Milwaukee 14"-24" Rubber Lined Valves; Dead End Capability Alert Notice

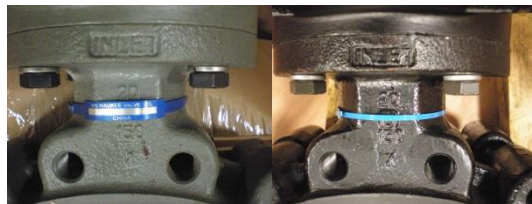
For over the last 15 years, our 14"-24" rubber lined butterfly valves have been (and remain) unidirectional dead-end capable to 150 psi.

From mid-1994 (the time of their introduction into our product offering) until the end of CY 2001, however, these valves were NOT dead end capable.

1. Any 14"-24" Milwaukee rubber lined butterfly valve that is known to have been purchased prior to the end of CY 2001, and that does not have 'INLET' marked on the periphery of the bonnet pad (as described further below), was not intended for dead end service and should ***never*** be used in that application, even for a brief period.

2. The 'INLET' marking, which should appear on all valves bought after the start of CY 2002, indicates the valve is rated for unidirectional dead end service. This marking is located on the periphery of the bonnet pad, on one side of the valve only (the same side as the pressure marking, the size, and our cast in trademark), as shown in the photos below; the gray valve is our C Series; the black valve is our M series. Both photos show a 20 inch valve, the M and C series being identical except for color. All sizes from 14"-24" have this same marking at the same location. The 'INLET' marking should be facing toward the pressure if the valve is applied on dead end service (see also the note at the bottom of this page).
